APPLICATION FOR PERMIT

Location 1037 Forest Avenue Within Fire Limit Dist. No. _____
Owner's name and address Merrill Transport Co., 1037 Forest Ave. Telephone _____
Lessee's name and address _____ Telephone _____
Contractor's name and address Maine Home Insulation Co., 121 Commercial Ave. Telephone 2-0004
Architect _____ Specifications _____ Plans yes _____ No. of sheets 1
Proposed use of building Truck terminal No. families _____
Last use _____ No. families _____
Material Brick No stories 1 Heat _____ Style of roof flat Roofing _____
Other buildings on same lot _____
Estimated cost \$ 4500. Fee \$ 5.00

RE: Alterations to Storage Building and
Parts Building Addition for Merrill
Transport Company, 1037 Forest Avenue
Portland, Maine

TO: Merrill Transport Co., 1037 Forest Ave. DATE: June 8, 1956
FROM: Warren McDonald, Inspector of Buildings
SUBJECT: Installation of 2000 gallon kerosene tank at 1037 Forest Avenue

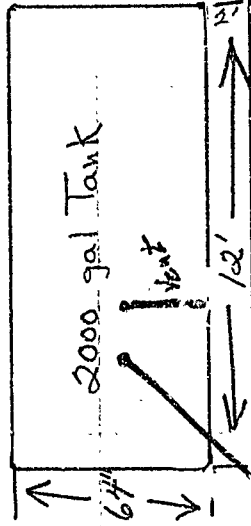
Before tank and piping is covered from view, installer is required to notify Fire Department Headquarters of readiness for inspection and to refrain from covering up until approved by the Fire Department.

This tank of 2000 gallons capacity is required to be of steel or wrought iron no less in thickness than No. 7 gauge; and before installation is required to be protected against corrosion, even though galvanized, by two coats of tar, asphaltum, or other suitable rust-resisting paint, and special protection wherein corrosive soil such as cinders or the like.

Pipe lines connected to underground tanks, other than tubing and except fill lines and test wells, must be provided with double swing joints arranged to permit the tank to settle without impairing the efficiency of the pipe connections.

Owner and installer will have to bear the responsibility for the structural capacity of the tank to support loads from above such as heavy motor trucks.

If tank will be so located as to be subjected to the action of tide water or "ground" water, adequate anchorage or weighting must be provided to prevent "floating" when tank is empty or nearly so.
